**BHCD CODES AND STANDARDS COMMITTEE
2012 CODE CHANGE CYCLE – BOOK 3
March 25, 2013**

Code Change Form for the 2012 Code Change Cycle

Code(s) and Section(s): R507 - Decks

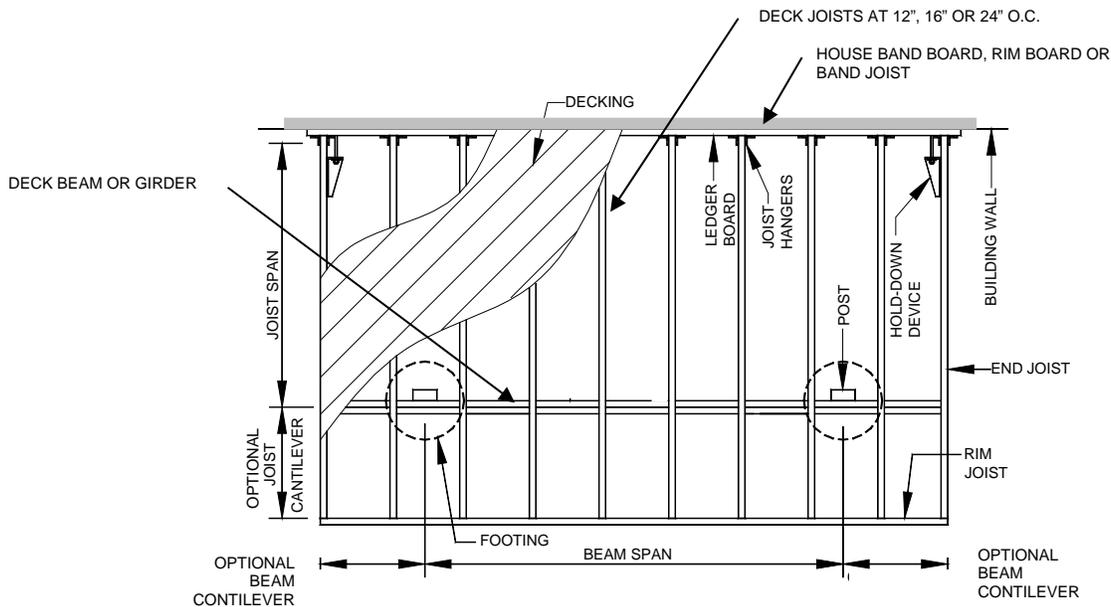
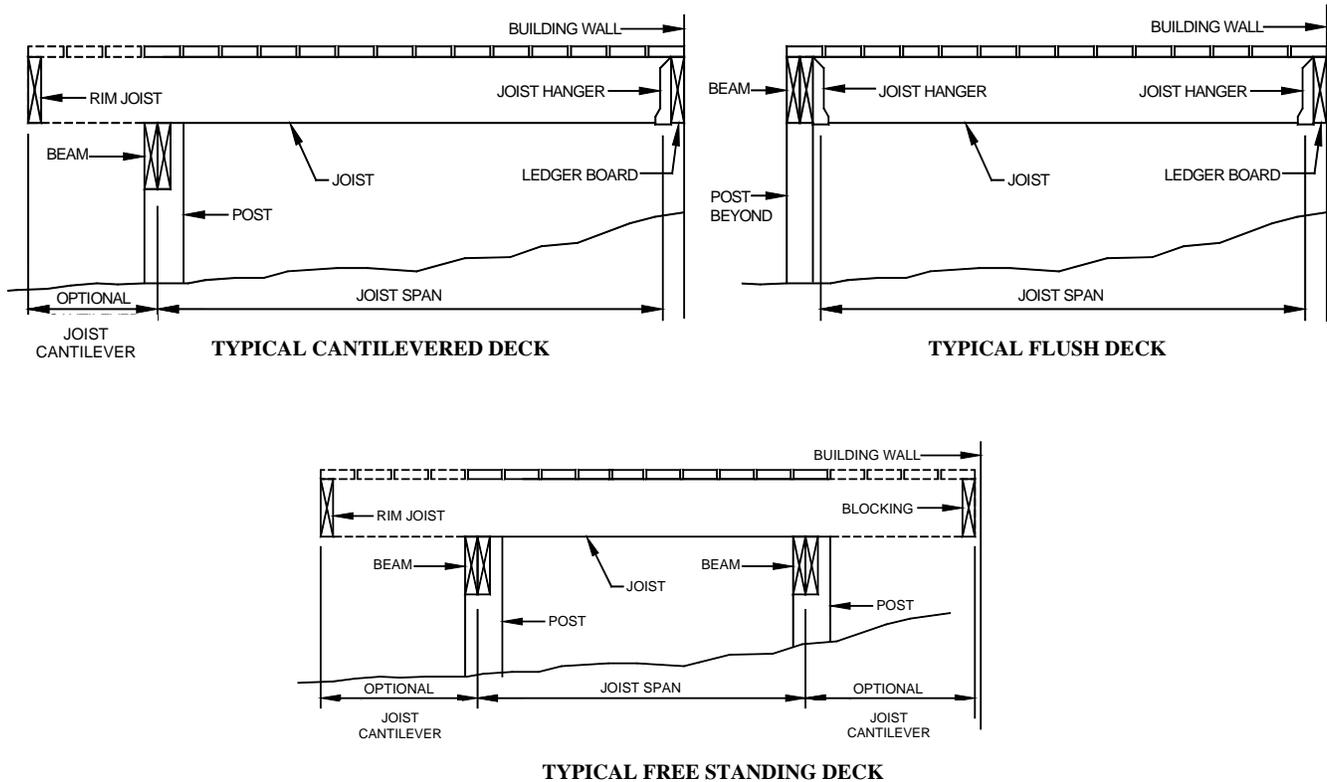
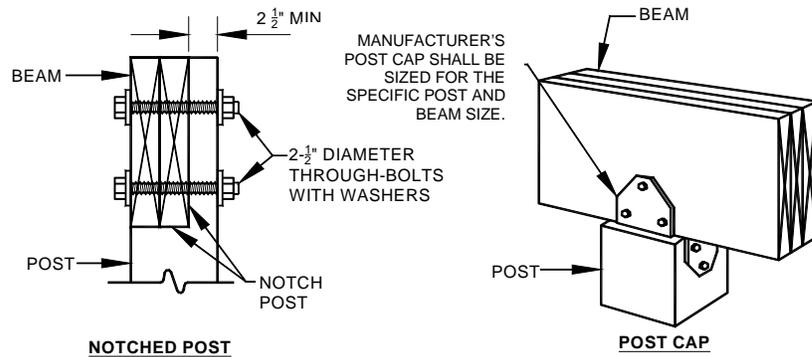
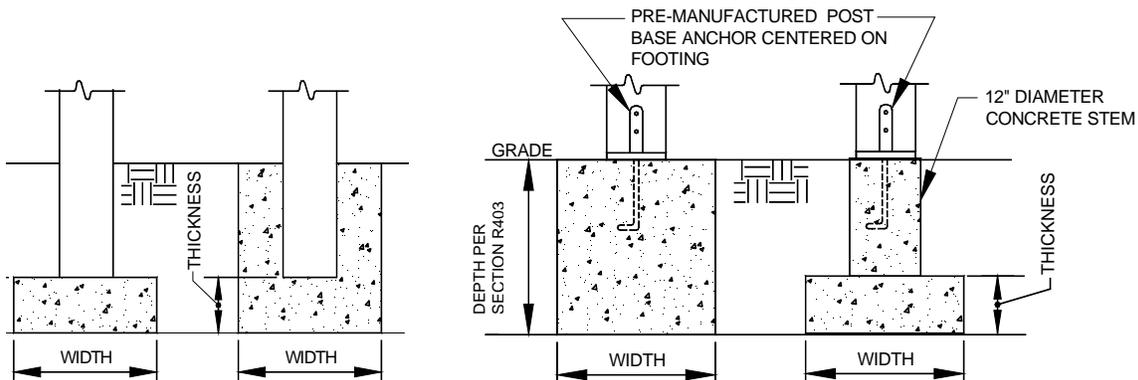
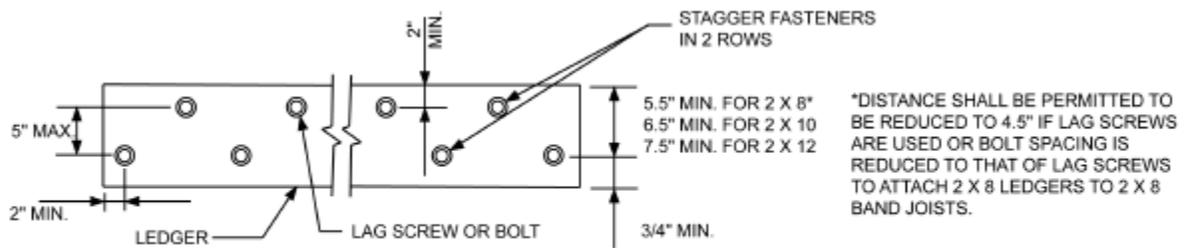
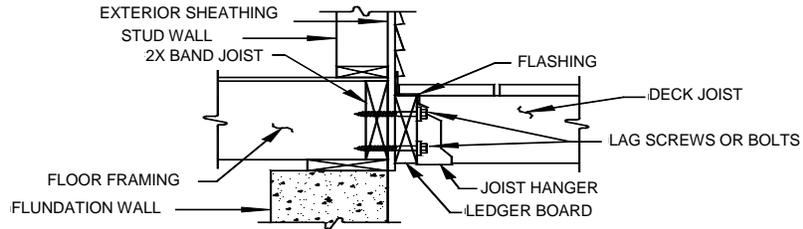
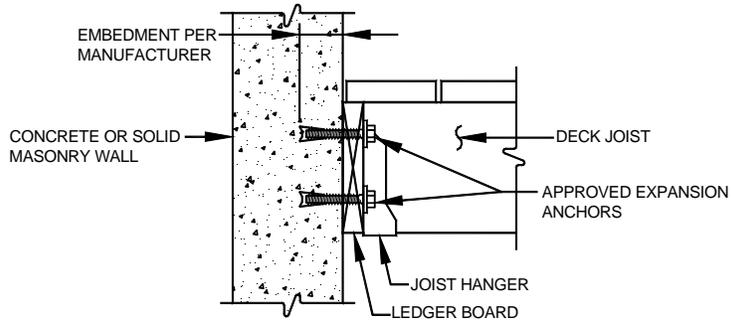
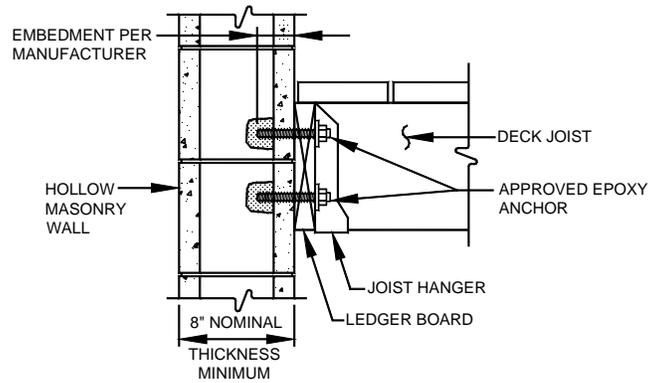
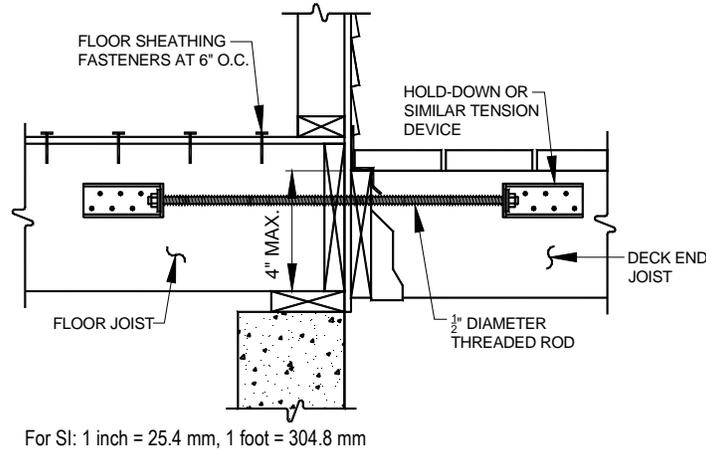
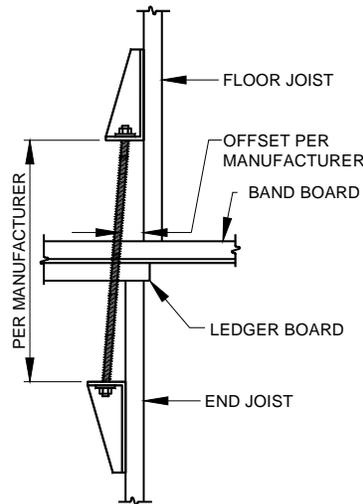
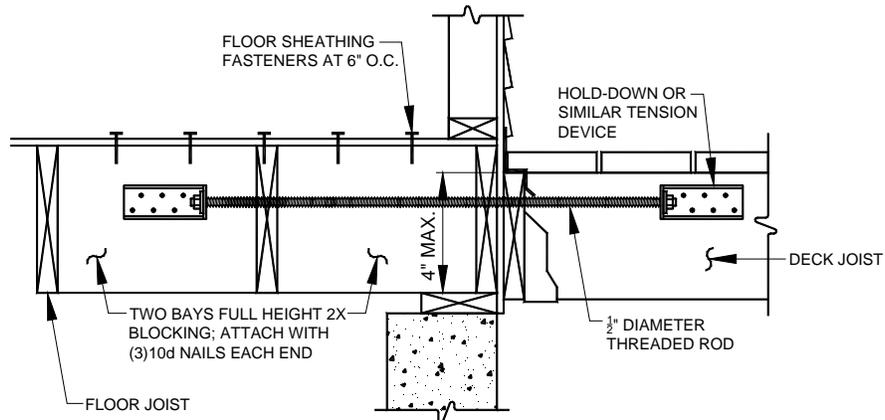
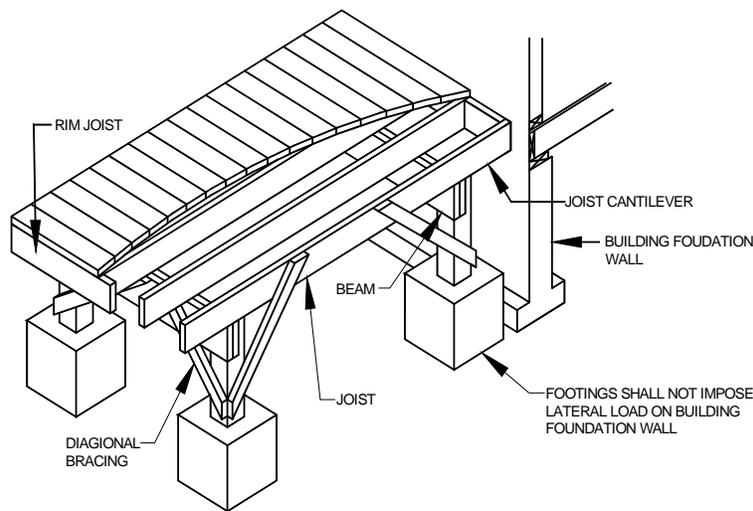
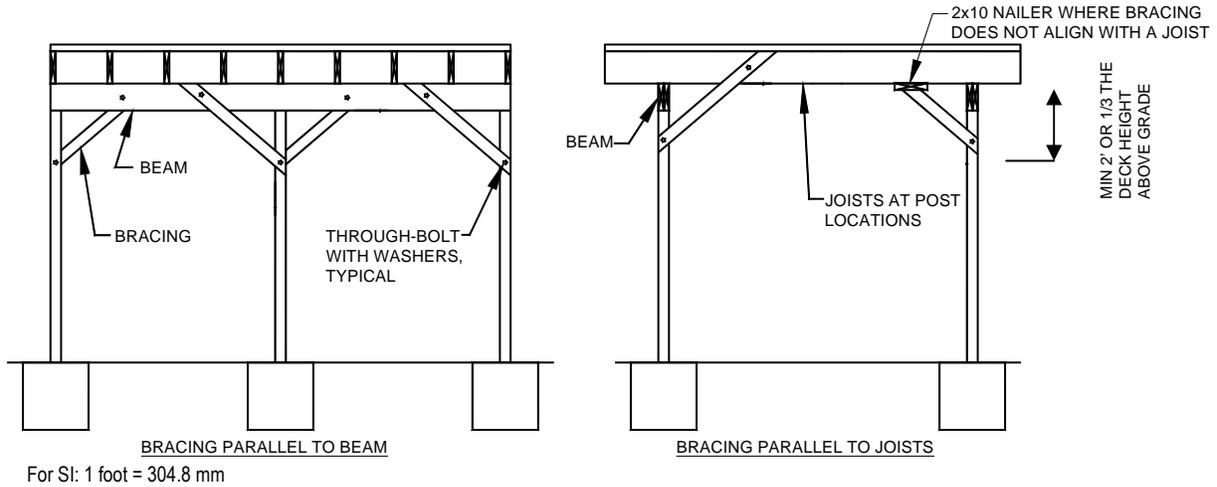
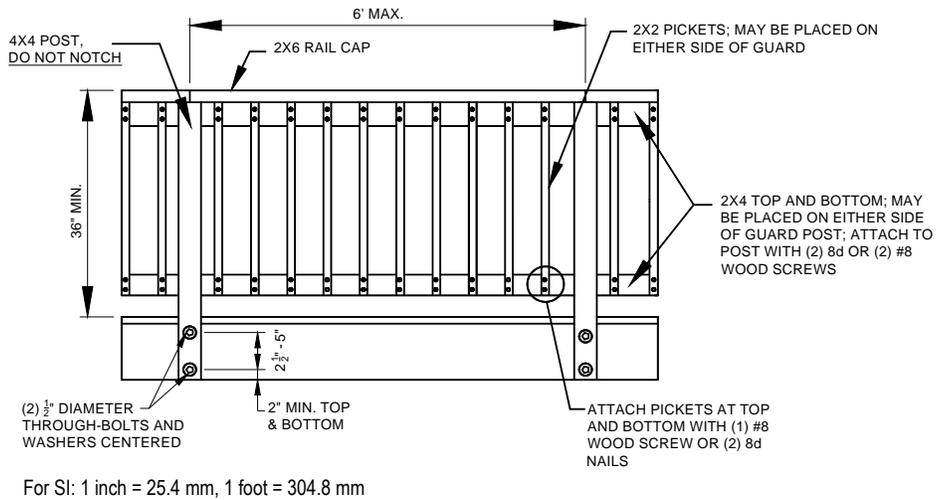
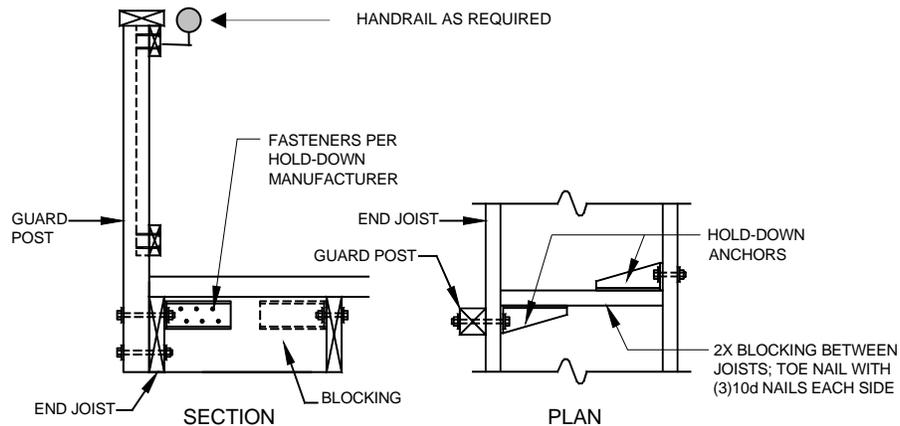
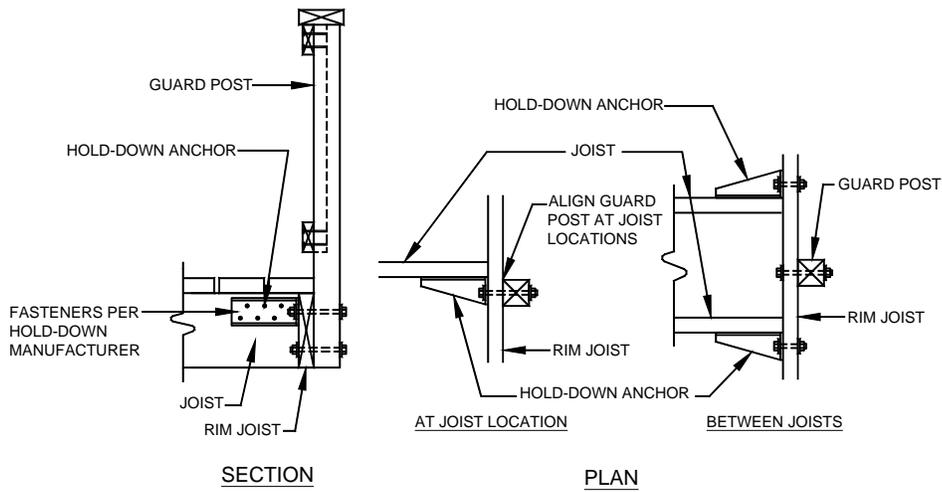
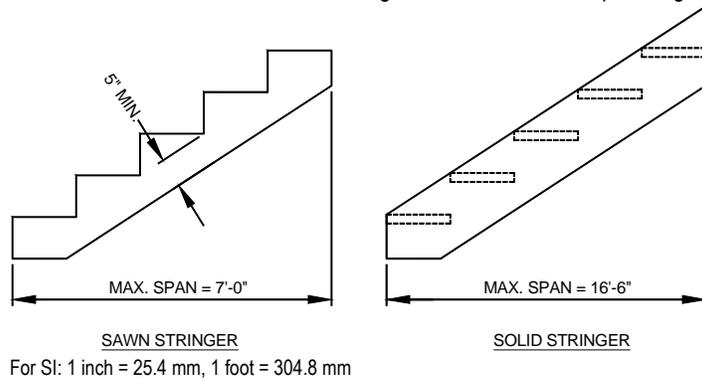
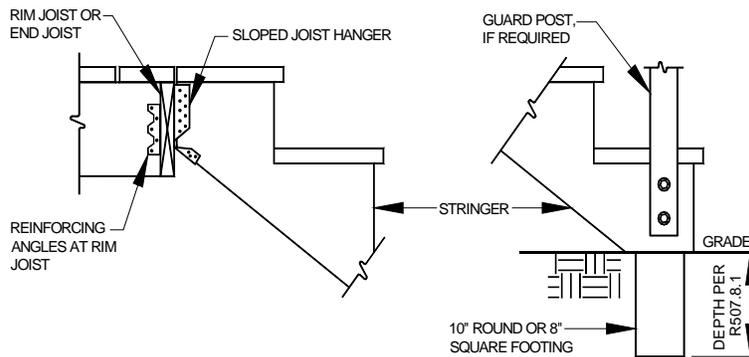
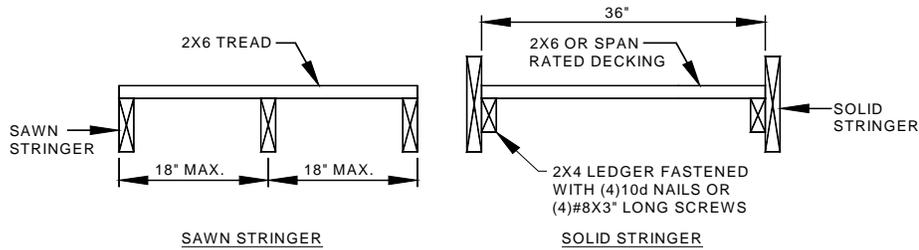
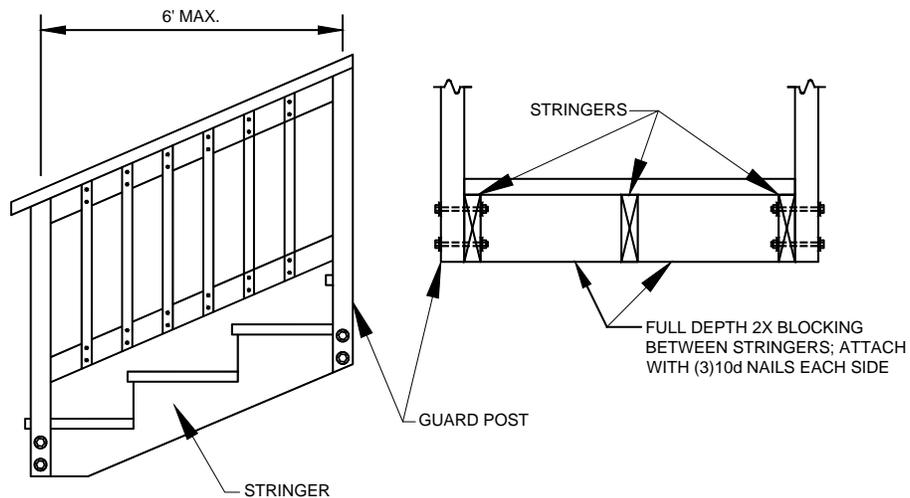
Delete Section R507 and replace it with the following:

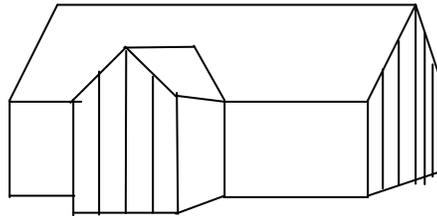
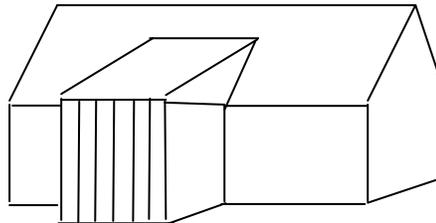
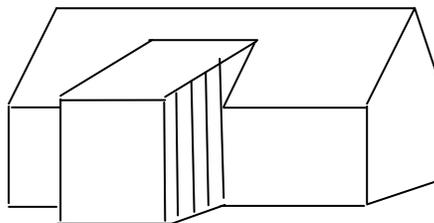
Table R602.3.1 has been the source of a lot of confusion. The footnote b is seldom read or understood. This change is submitted to:

1. Eliminate the table - the source of the confusion
2. Provide clarification as to where it can be applied (see the three options below)
3. Write in code language the requirements for when tall studs can be used.
4. To say that you cannot use these tall studs where the wall is an integral part of the wall bracing system.

Tall studs could be used for two-story gable ended wall supporting nothing more than self weight.

Tall studs could be used for a two-story projection where the roof framing runs perpendicular to the wall so long as the overbuilt roof has a trib length of 6' or less

Tall studs could be used for a two-story projection where the roof framing runs parallel to the wall such that it was supporting nothing more than self weight

**FIGURE R602.3(2)
FRAMING DETAILS**

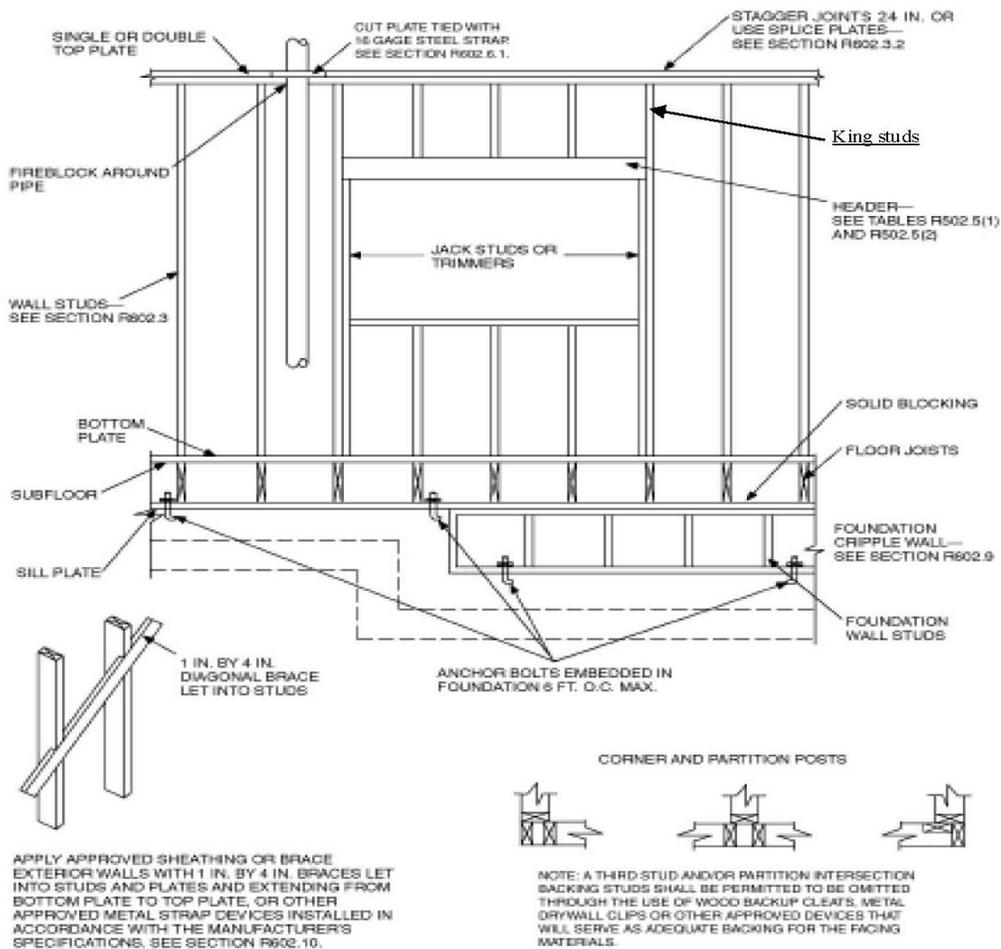
Code(s) and Section(s): Figure R602.3(2) and Section R602.7.4

Add new Section R602.7.4 as follows:
